84 Queens Park Road, Queens Park – Alterations and additions to a detached dwelling including a first floor addition, double garage at the rear and swimming pool (DA 104/2010)

Report dated 13 May 2010 from the Development and Building Unit.

Development Assessment Report	
Development Application No.	DA-104/2010
Address	84 Queens Park Road, Queens Park
Lodgement Date	16 March 2010
Proposal	Alterations and additions to a detached dwelling including a first floor addition, double garage at the rear and swimming pool.
Zoning and relevant controls	Waverley Local Environmental Plan 1996 <ul style="list-style-type: none"> • Residential 2 (a) – Low Density Waverley Development Control Plan 2006 <ul style="list-style-type: none"> • Part D1 – Dwelling House and Dual Occupancy
Owner	Mrs Andrea Shields
Applicant	Mrs Andrea Shields
Building Classification	1a
Submissions	Two (2) submissions – Original Proposal
Issues	NSW Land and Environment Court Appeal lodged. Excavation, Setbacks, Heritage, Accuracy of Plans
Recommendation	Deferred Commencement consent

SCALE	DATE	DESIGN	CHECKED
1:100 @ A1	11/03/10	JD	JH
DRAWING NO	PROJECT NO	SHEET NO	TOTAL SHEETS
DA2000	0801	01	01

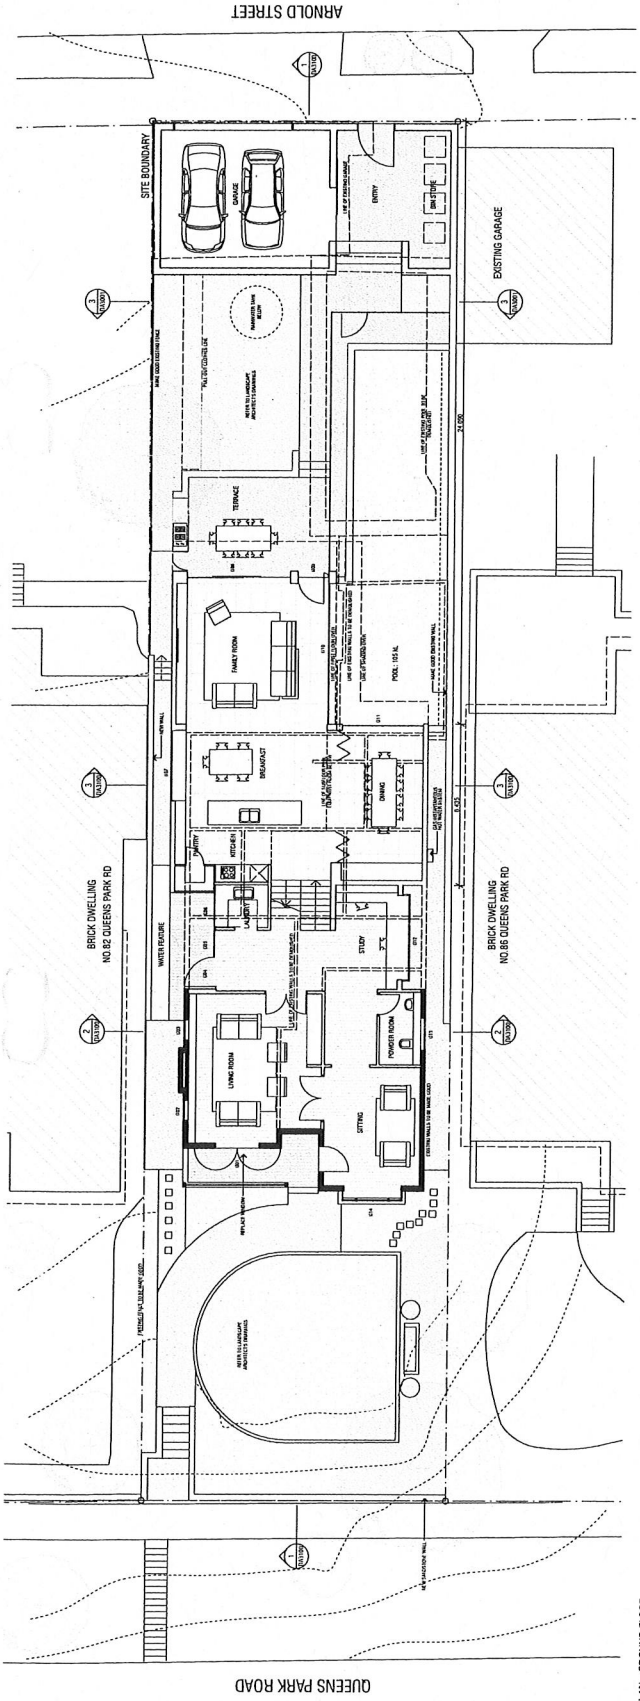
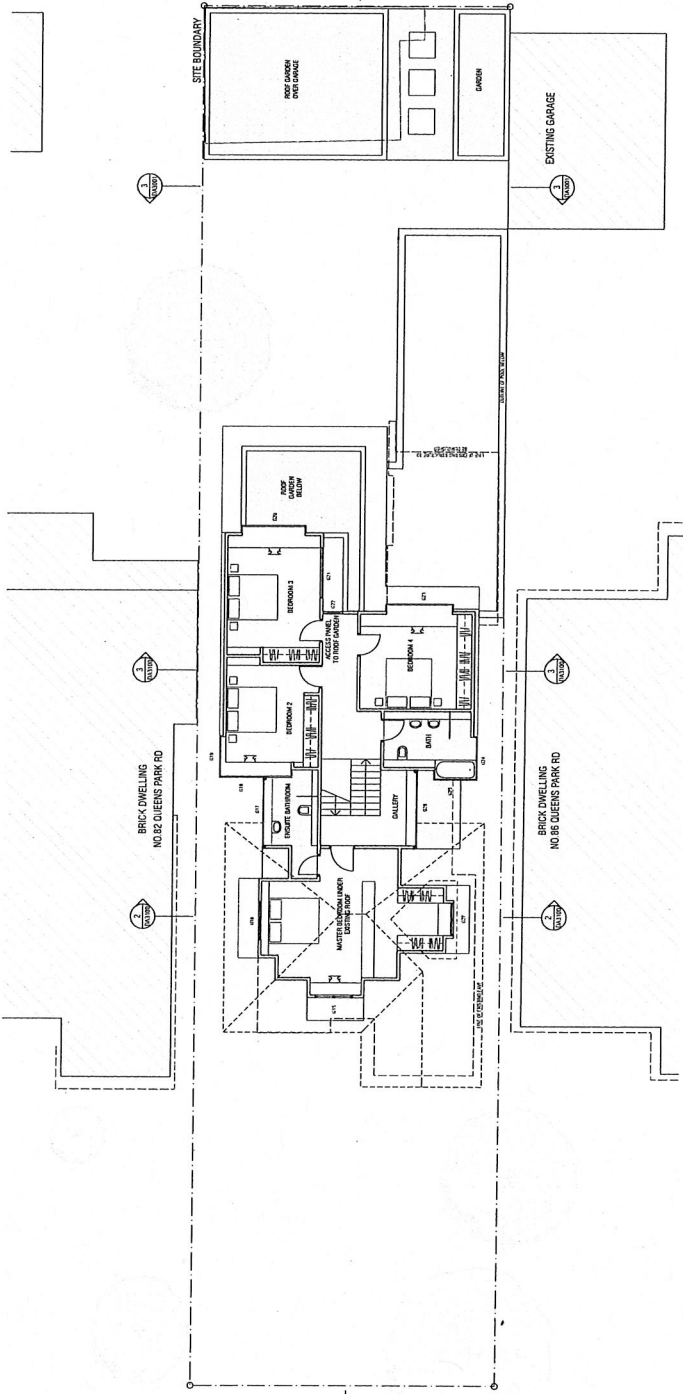
Nevertheless, the plans submitted are inaccurate in respect to the basement level that is not shown and the works to the existing dwelling is unclear. Side elevations are also not clear, as the size and position of windows were also partly covered by fencing in the elevations provided. In this regard accurate plans are sought via deferred commencement consent.

- (i.) A separate demolition plan be provided for the existing house and the ground floor plan amended to show an accurate layout of existing work to be retained. In particular, the front two rooms and associated openings, in a longitudinal sense, are to be generally retained.
- (ii.) Accurate side elevations reflecting the above are to be submitted (free of side fencing) and new ground floor openings are to be highlight window (ie sill heights a minimum of 1700mm above the finished floor level) where these windows oppose neighbouring side windows.
- (iii.) A floor plan for the basement level is to be submitted, this area is to be generally no larger than 16 sqm and setback a minimum of 1 m from the side boundary.

- (a) The front door entry to the premises is to be off the front verandah and the secondary side entry off Queens Park Road is to be deleted and / or used as an internal drying area for the adjoining laundry only.
- (b) The proposed windows/glazing to the ground floor study, laundry and first floor bathroom areas and the stairwell are to be obscured glass or highlight windows with a minimum sill height of 1700mm above the finished floor level.
- (c) Existing side masonry fencing is to be retained. Where on the east side, a portion of the existing wall on the side boundary is to be demolished and rebuilt as a boundary fence, that fencing is to be no higher than the existing wall (that being RL 69.29)
- (d) The brick fence being designed in accordance with the requirements of Council's Standard for Brick Fences.

LANDSCAPE PLAN
PNG NO. 0410

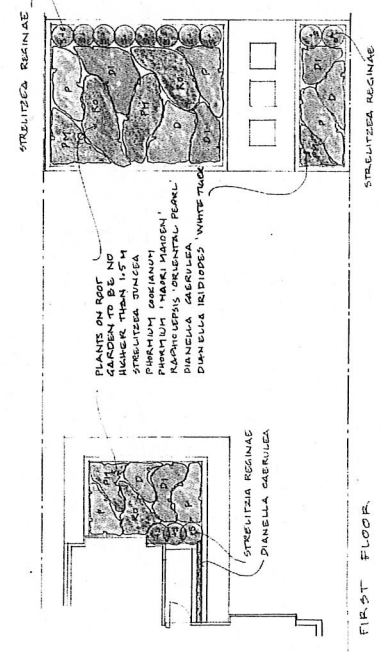
The Landscape Plan is to be amended by the following changes:

- (a) Delete proposed plantings on the eastern and western sides of the dwelling. Species proposed will not grow well in conditions of low light. Replace with more suitable species;

- (b) The proposed fencing on the western boundary needs to remain as a timber paling fence;
- (c) Indicative Plant Schedule to show a two (2) 100-litre container size tree to be planted within the front setback of the site.

- (d) The Prunus species (Flowering Cherry) tree located at the front western boundary of 86 Queens Park Road has to be shown on the plan; and
- (e) All landscaping on the site (trees, shrubs and groundcovers) are to be representative of a minimum 50% local native species.

- (f) Garden bed along the rear western side of the property be increased to a minimum of 2.0 metres wide and proposed replacement species of *Acmena smithii* 'Compact' be planted no closer than 1.0 metres from the boundary fence.
